Access Compliance Report

Public Rights-of-Way

(Curb Ramps)

Intersection ID: N/A	Main Street: OUTLETS_BV	Cross Street: DESIGNER_DR	Location: SW
ADA ID: 3A1B68699939	Ramp Type: PerpDiag	Initial Pass/Fail: Fail	Overall Compliance: No
Severity Score: 1.25			
Codes/Mitigation Info/Possible Solution		Field Measurements/Component Compliance

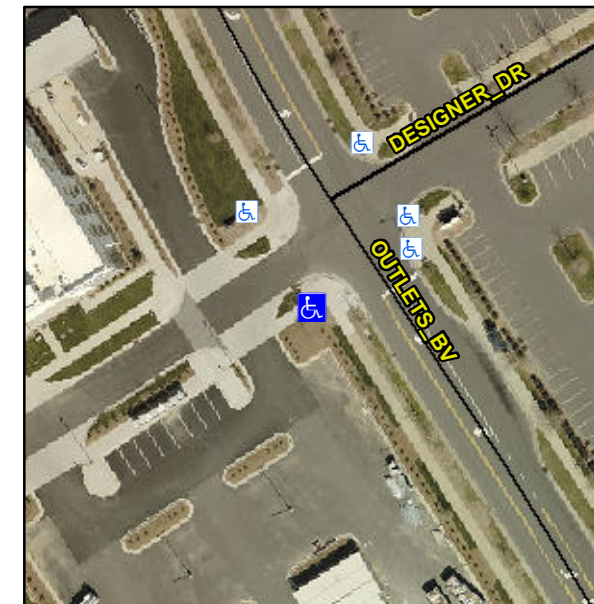
R304.5.3

Compliance	Description	Data	Compliance	Description	Data
N/A	Ramp Length (in)	97.0	Yes	Ramp Slope (%)	6.1
Yes	Ramp Width (in)	48.0	No	Ramp XSlope (%)	2.7
N/A	Flare Type LT	N/A	N/A	Flare Type RT	N/A
N/A	Flare Slope LT (%)	N/A	N/A	Flare Slope RT (%)	N/A
N/A	Flare Traversable LT?	N/A	N/A	Flare Traversable RT?	N/A
N/A	Landing Length (in)	N/A	N/A	DWS Provided?	N/A
N/A	Landing Width (in)	N/A	N/A	DWS Contrast?	N/A
N/A	Landing Slope (%)	N/A	N/A	DWS Length (in)	N/A
N/A	Landing X Slope (%)	N/A	N/A	DWS Full Width?	N/A
N/A	Landing Curb? (Y/N)	N/A	N/A	DWS Offset (in)	N/A
N/A	Shared Landing?	N/A			
N/A	Gutter Ponding?	N/A	N/A	Gutter Slope (%)	N/A
N/A	Gutter Lip Ht (in)	N/A	N/A	Gutter X Slope (%)	N/A
N/A	Painted X Walk1?	No	N/A	Painted X Walk2?	No
	X Walk 1 Direction	To E		X Walk 2 Direction	To N
N/A	X Walk 1 Width (in)	N/A	N/A	X Walk 2 Width (in)	N/A
	X Walk 1 Slope (%)	4.7		X Walk 2 Slope (%)	2.4
	X Walk 1 X Slope (%)	2.9		X Walk 2 X Slope (%)	3.2

Remove & Replace Curb Ramp With Two New Directional Ramps or Equivalent.
